KENWOOD

ASB-999

Service Bulletin

Subject: TS-950SDX No Beep in Headphones

Control Unit (X53-3380-00)
Foil Side View

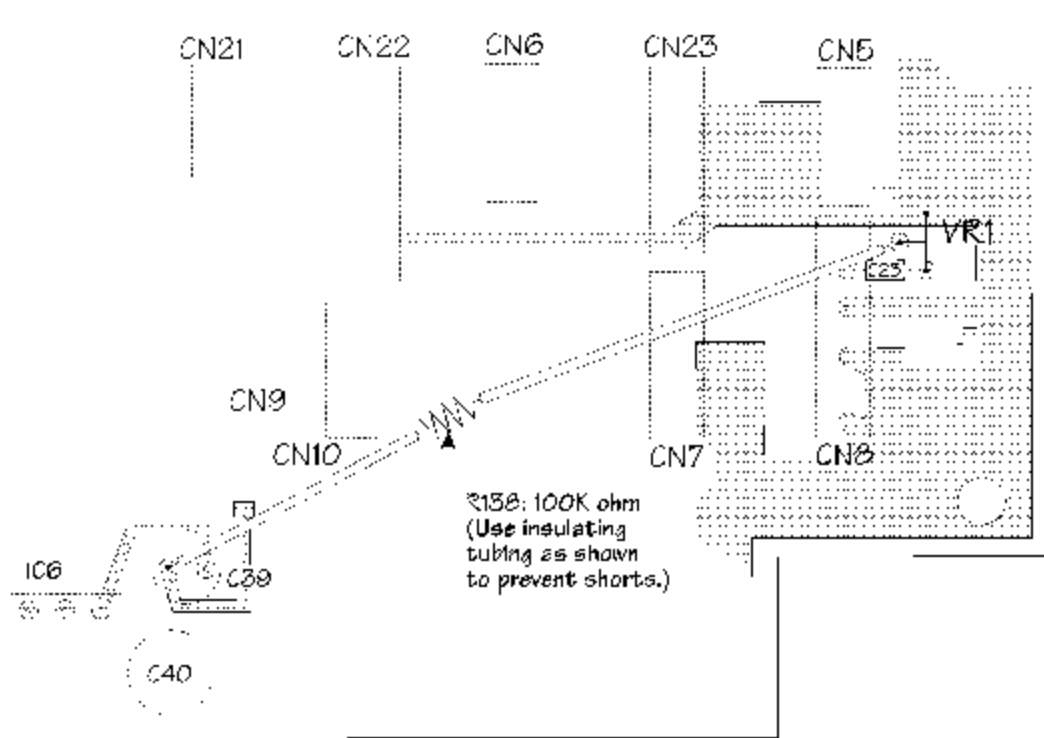
In this design the SUB AF PA circuit supplies audio when using a monaural headphone, and the MAIN AF PA supplies audio to the right speaker of a stereo headphone. The audio confirmation tone is not applied to both the SUB AF PA and the MAIN AF PA. To simplify circuit design the tone is only routed to the MAIN AF PA. Unfortunately this left monaural users without a confirmation tone and stereo headphone users with a confirmation tone only in the right side of the headphones.

The following modification permits the user to hear the audio confirmation tone from both sides of a stereo headphone and from a monaural headphone.

R138: 100K radial lead 1/4 watt resistor

3. Remove one screw from each side of the front panel and tilt the front panel forward.
4. Add R138 from the wiper arm of VR1 to the negative side of C39 as shown in the accompanying diagram.
5. Reverse steps 1 through 3 to reassemble.
